**Cnr Reserve & Balcombe Road, Beaumaris**

## **Arboricultural Construction Impact Assessment**

**Thursday, 24 November 2016**

Ref: 4068 161208 CIR Stewart Cnr Reserve & Balcombe Beaumaris Rds

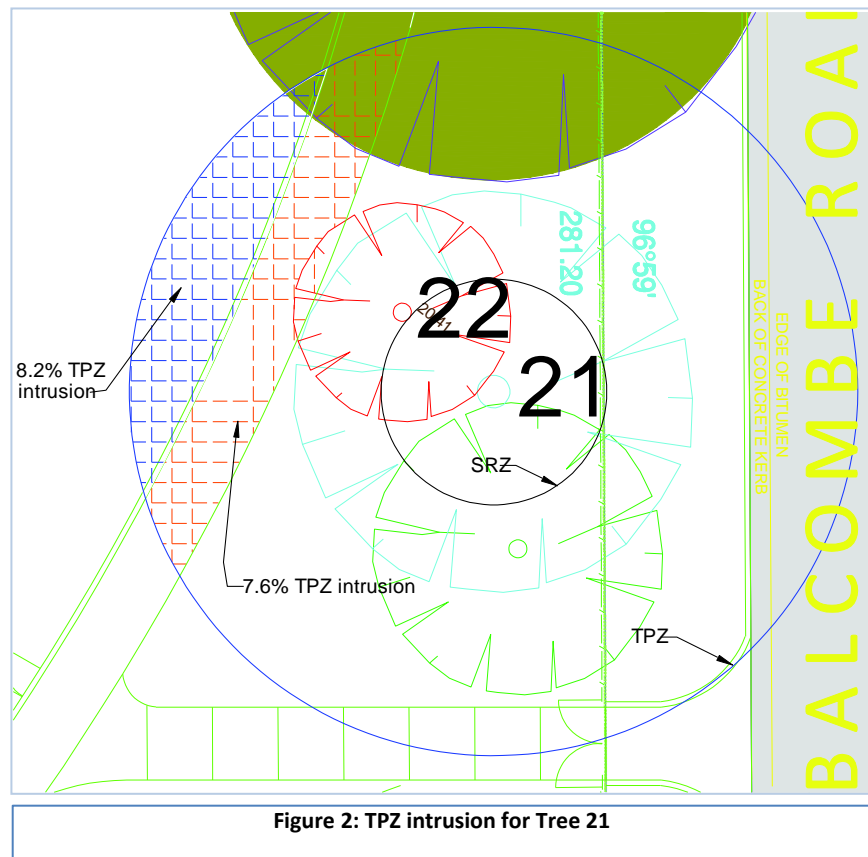
An oval and walking track is proposed to be constructed to the south of this tree which would occupy a combined 15.8% of this tree's TPZ (Figure 2).

Given that a considerable section of this tree's TPZ is occupied by the poor growing conditions beneath Balcombe Road, it is likely that the tree has an asymmetrical root plate, with a higher proportion of roots in the area of the proposed oval to the south of the tree.

Under the current plans the footpath will occupy approximately 7.6% of this trees TPZ. This path will be constructed from crushed rock and installed at approximately existing grade and as such will have little effect on any tree roots within this area.

The oval is to be excavated to a depth of 0.5 metres to allow the installation of irrigation.

Given that the tree is expected to have a higher proportion of its root mass within this area, it would be advisable to avoid excavation within this trees TPZ, and install the irrigation outside of this area.

If possible, the sprinkler systems should be directed into this area to allow the watering of turf without requiring the destruction of tree roots present within this area.

Figure 4: TPZ intrusion for Tree 32

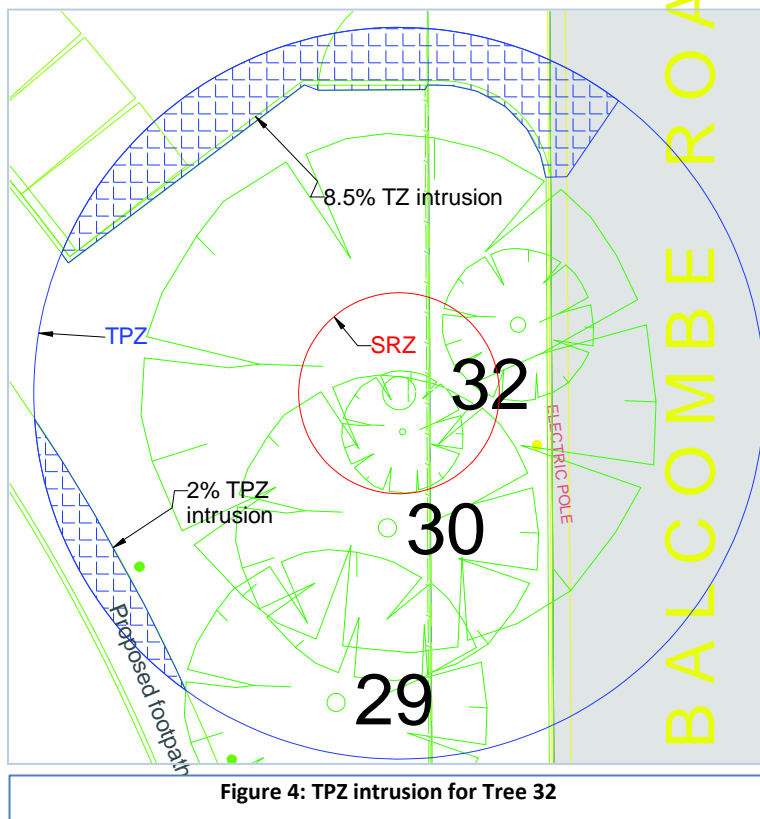
It is proposed that a carpark be constructed to the west of the tree, and a footpath be installed to the south.

The walking track will occupy approximately 2% of this trees TPZ, and given that the path will be constructed of crushed rock it will have little impact on existing roots provided that it is installed at roughly existing grade.

Given that the walking track is not likely to have an impact upon the tree roots and is not considered an intrusion, the 8.5% intrusion for the proposed

carpark falls below the 10% allowed under *AS4970 (2009) Protection of Trees on Development Sites*, and is therefore unlikely to effect the health or longevity of this tree.

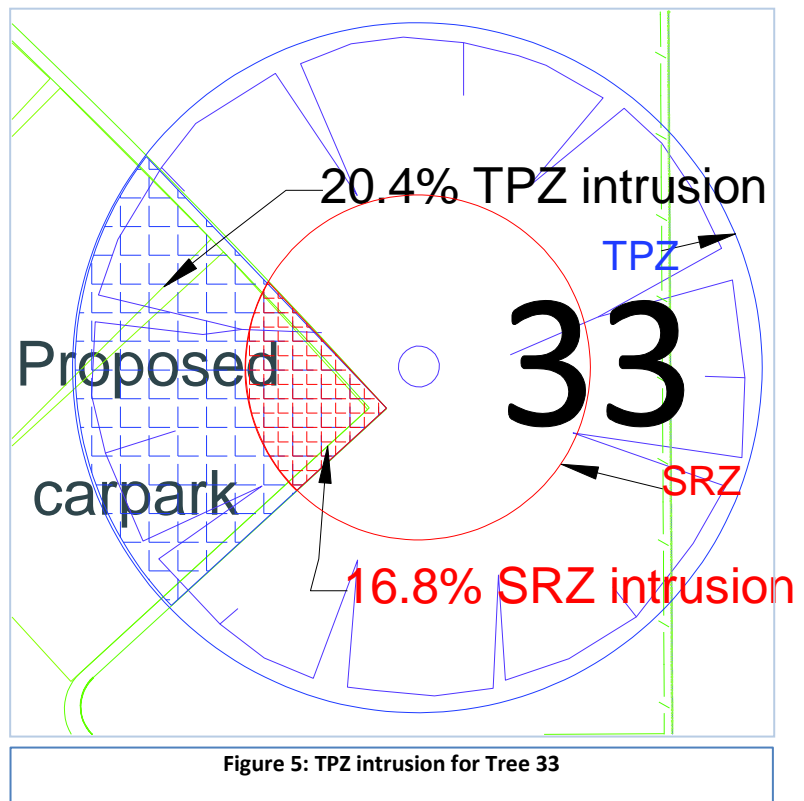
A carpark is proposed to be installed immediately to the south of this tree (Figure 5). The carpark would occupy approximately 20.4% of this tree TPZ, and 16.8% of the tree's SRZ.

Should the carpark be constructed at or above existing grade, and measures were undertaken to protect the roots and soil profile within the TPZ, this tree would remain viable within the proposed development.

Measures would be undertaken to protect against soil compaction and root damage, such as Geoweb cells per earlier recommendations.

If constructing at or above existing grade is not a viable option, then the nearest carpark would need to be sacrificed to successfully retain this tree.

Should neither of these options be selected, the tree will not remain viable alongside the proposed car park and should be removed.

Figure 6: TPZ intrusion for Tree 44

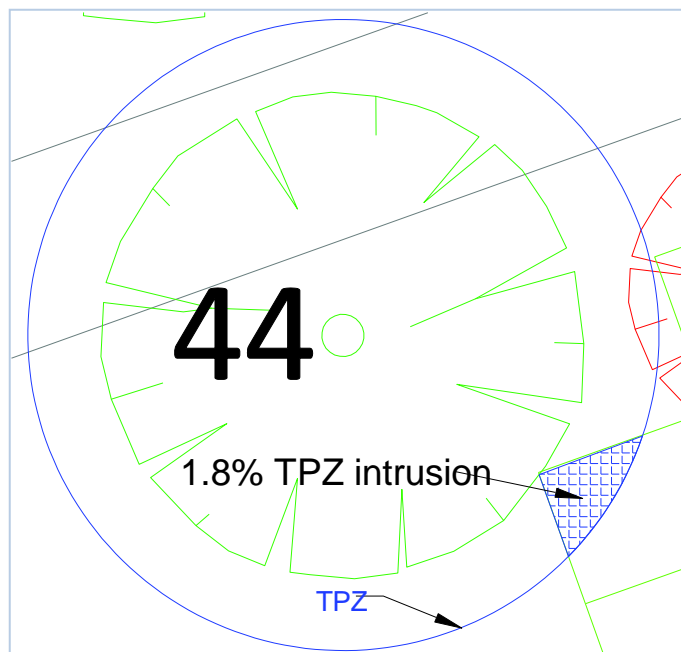
The proposed carpark will occupy approximately 1.8% of this trees TPZ.

Under *AS4970 (2009) Protection of Trees on Development Sites* this is considered a minor intrusion, and will not significantly impact the health or longevity of this tree.

Figure 7: TPZ intrusions for Tree 79

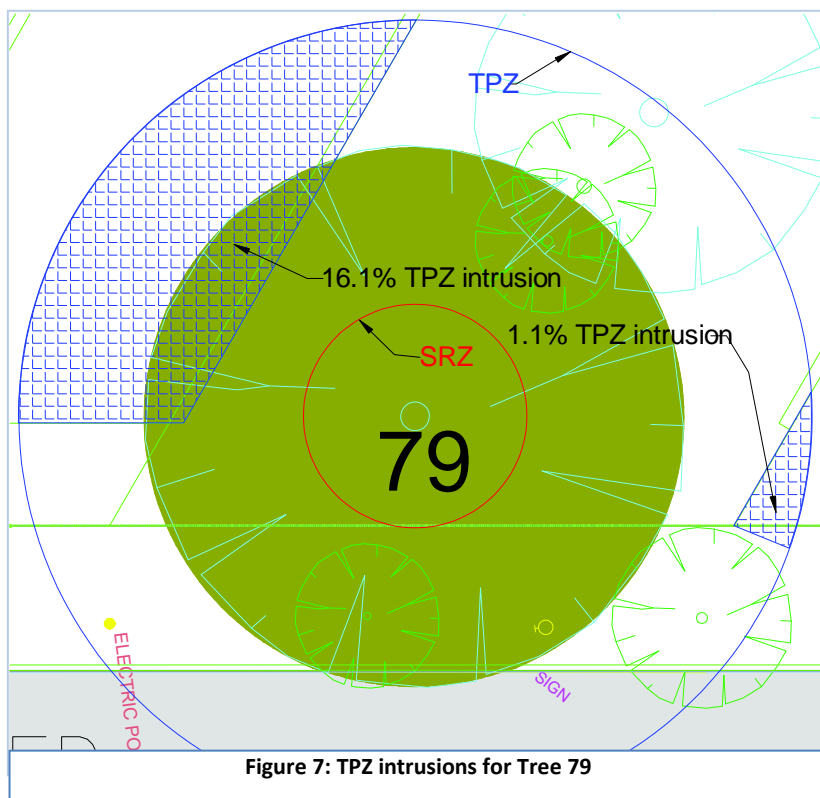
Retaining walls to the north and south of this tree will occupy approximately 17.2% of this trees TPZ (Figure 7).

Figure 8: TPZ intrusion for Tree 91

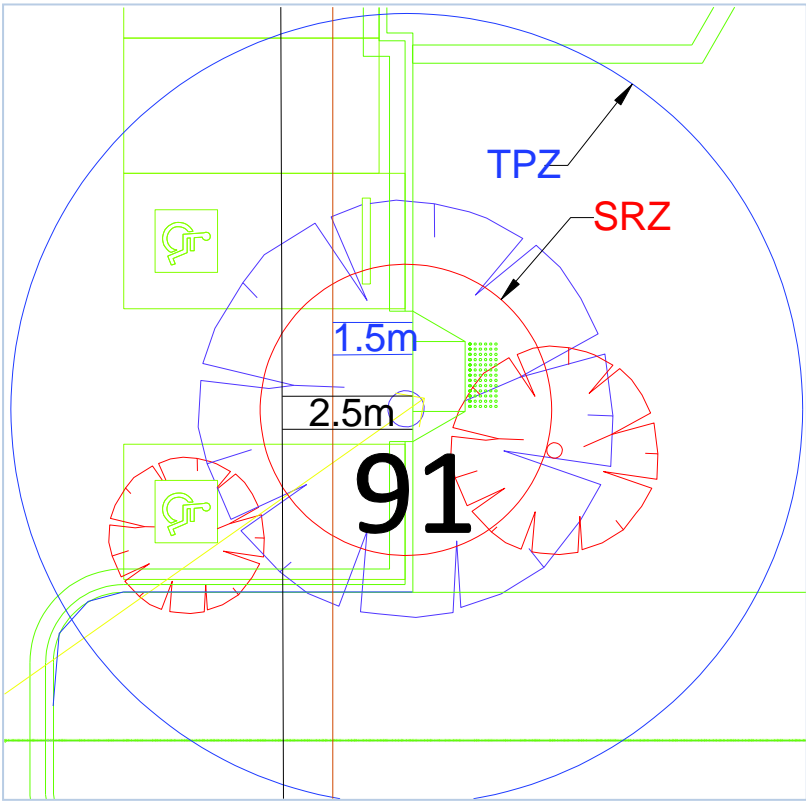
Accordingly this tree cannot be retained under the currently plans.

However, were the soccer pitch to the south be reduced in size as to allow to carpark to move a minimum of 2.5 metres to the south, then root sensitive construction methods could be adopted to ensure the viability of this tree.

A permeable Geoweb system (or similar) should be placed over the areas of TPZ and be constructed upon to reduce soil compaction, and to allow the movement of water and oxygen into the soil.

Figure 10: Amended plans to allow retention of trees

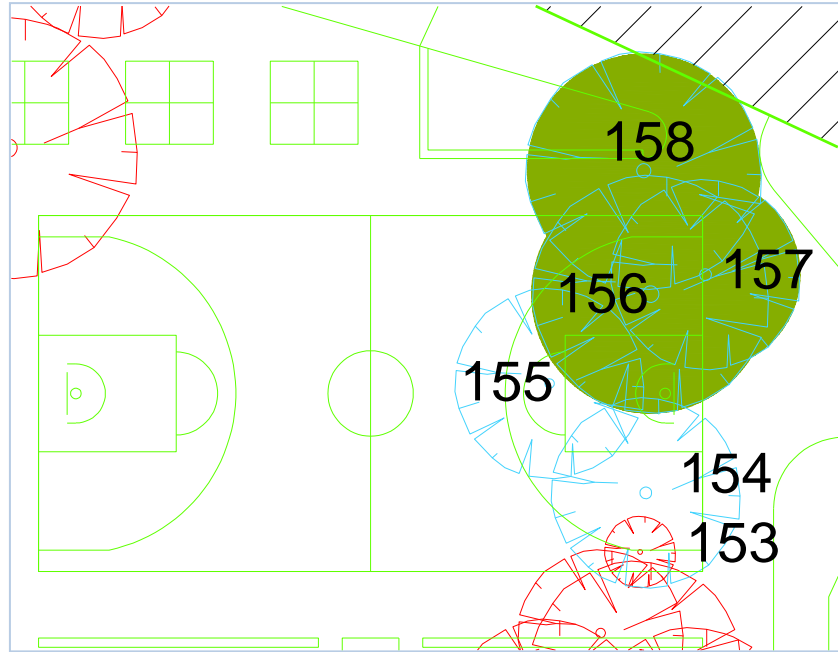
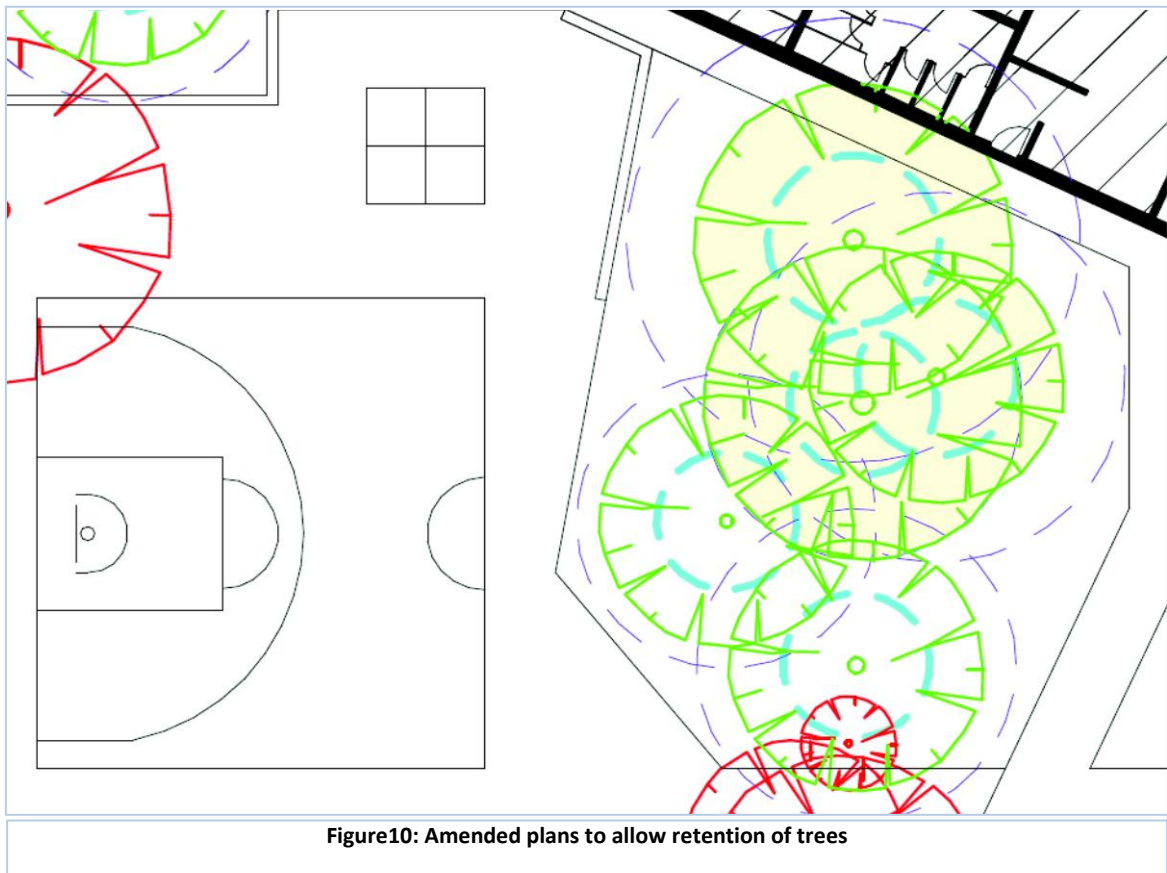
Under the original plans these tree lay within the footprint of the proposed netball court, or the adjacent retaining wall and could not be retained (Figure 9).

However a redesign to reduce the netball court to a half court was created by the project architect, Sindy Kwok of Clarke Hopkins Clarke.

This redesign will allow for the retention of these Red Gums as no change to grade will be required, and the retaining

wall has been relocated (Figure 10).

Figure 11: TPZ intrusion for Tree 250

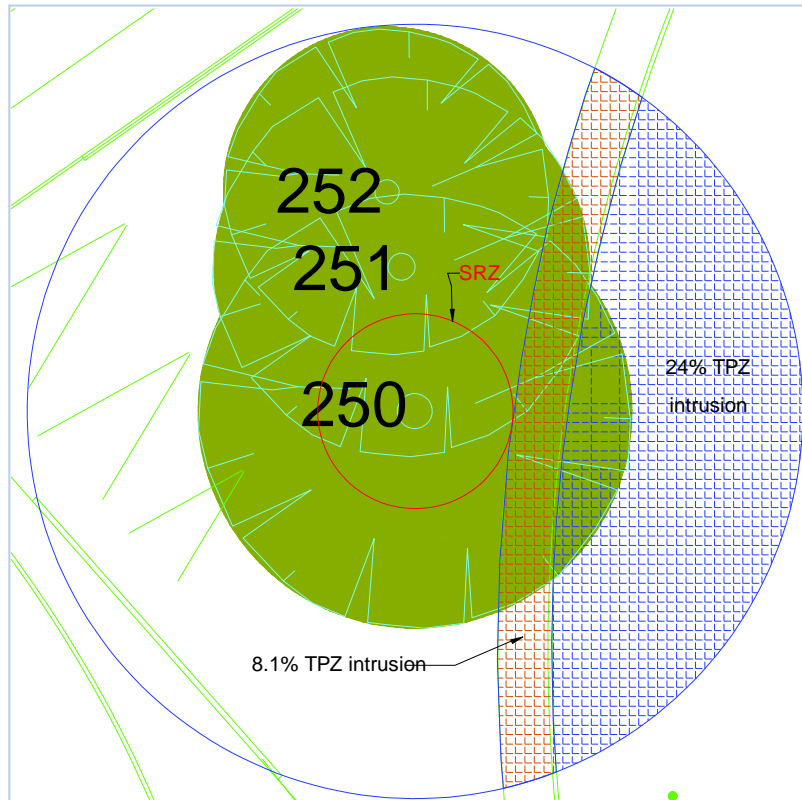
The proposed main (northern) oval and footpath will occupy approximately 32.1% of the TPZ of Tree 250 (Figure 11), and 38.4% of the TPZ of Tree 251 (Figure 12).

It is currently planned that the oval be excavated to a minimum depth of 0.5 metres to allow the installation of irrigation systems.

The removal of the roots within the soil profile will likely have a detrimental effect upon the health and longevity of these trees.

Should the excavation take place outside of the TPZ's of these trees, they will remain viable alongside the installation of the oval.

Figure 10: Tree 252 TPZ intrusion

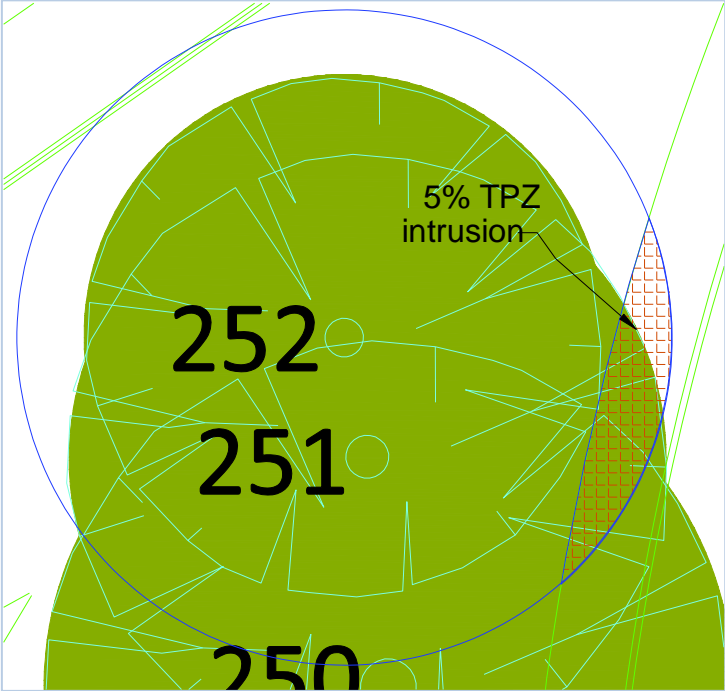
Under *AS4970 (2009) Protection of Trees on Development Sites*, this is defined as a minor intrusion and is not expected to impact significantly upon the health or longevity of this tree.

Figure 11: TPZ intrusion for Tree 253

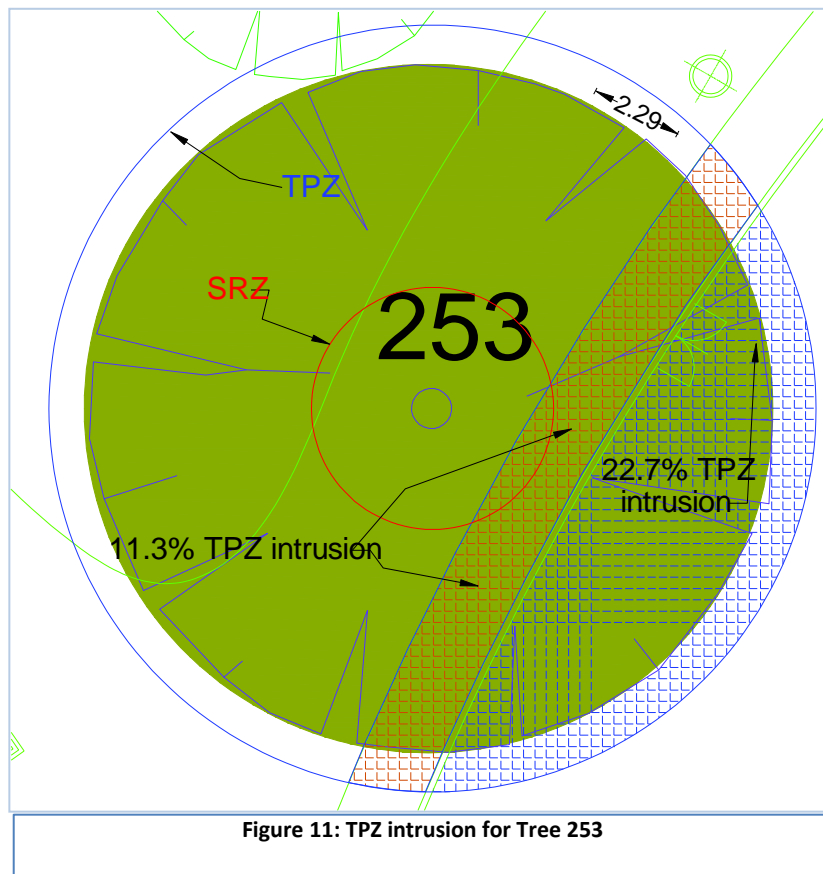
The proposed footpath and oval will occupy approximately 34% of this trees TPZ (Figure 14).

The proposed oval will occupy approximately 22.7% of this trees TPZ. Under the current plans this area will be excavated to a depth of 0.5 meters, effectively removing any tree roots within this area.

However was the irrigation to be installed outside of the TPZ with sprinklers facing inwards to service the turf within the TPZ, the actual impacts to tree roots in the area will be negligible. Accordingly, there will be little to no impact to the health or longevity of this tree from the development.

Figure 12: Required shift of sports oval to allow retention of T268 and 269

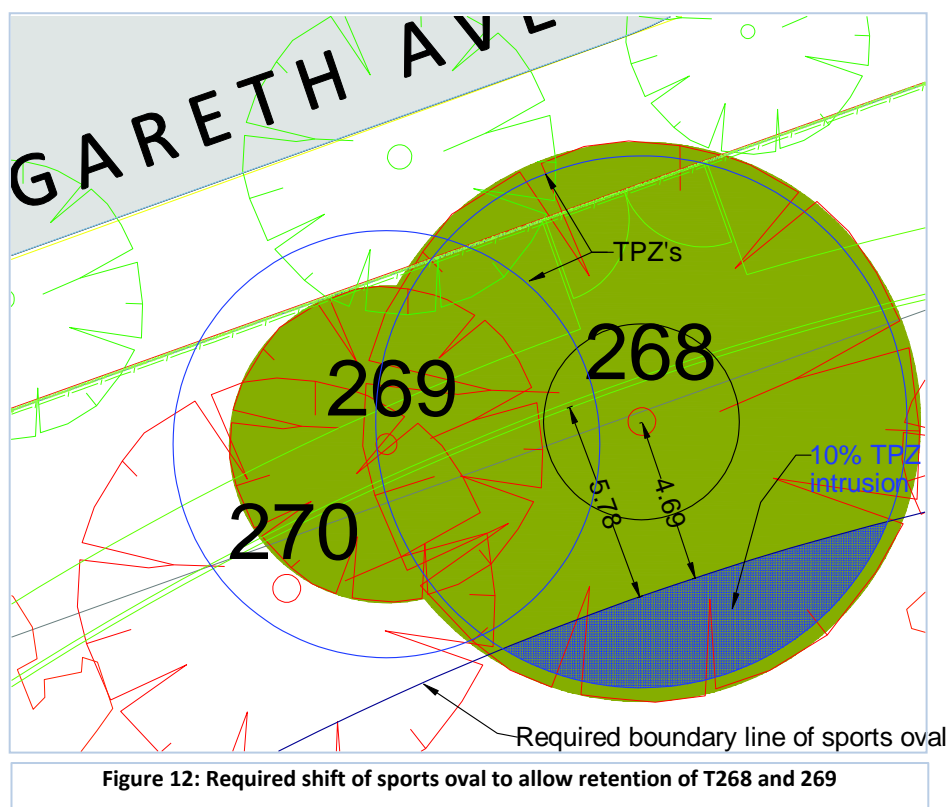
These trees are marked as removed under the current plans as the proposed development of the sports oval to the east of Gareth Avenue will fall over or directly adjacent to these trees.

However should the outer boundary of the sports oval be moved approximately 5.8 metres east by either shrinking or moving the footprint of the oval as illustrated in Figure 12, these trees could be retained alongside the proposed development.

The suggested relocation of the oval would reduce the impacts to T268 to approximately 10%, and see no impact to the TPZ of T269.

Provided that no excavation greater than 100mm is required in the construction of the oval, the oval will need only be required to clear the Structural Root Zones of these trees. In this case the oval would only need move approximately 3.9 metres to clear the SRZ of T268. Should excavation deeper than 100mm be required in the construction of the oval this will not be a viable option.

Should a greater encroachment than the 10% illustrated in Figure 12 be required to the TPZ's of these trees in the construction of the sports oval, it will need to be demonstrated that the trees will remain viable. Therefore a non-destructive tree root investigation will be required to ascertain the size and quantity of roots present within the footprint of the oval.

Figure 13: Tea Trees proposed to be removed (red) and retained (green) at Gareth Ave frontage

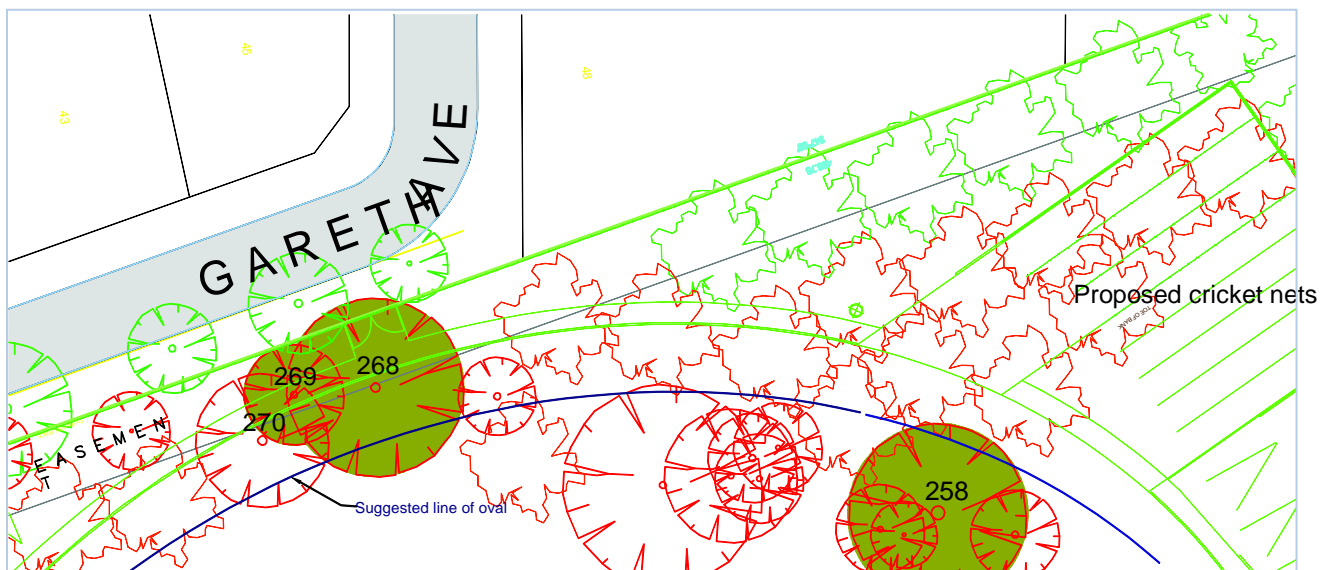
Many of these are proposed to be removed and are marked in red in Figure 13.

There are many Tea Trees not marked on the plans provided. Accordingly the tree locations in Figure 13 are used as a guide only.

Under the current plans the footprint of the proposed oval will fall directly over many of these Tea Tree making their retention unfeasible.

It is expected that some of these trees would be within the area proposed for the walking track around the oval and may require removal. However should the suggested 5.8 metre change to the plans occur the majority of the Tea Trees within this area could be retained.
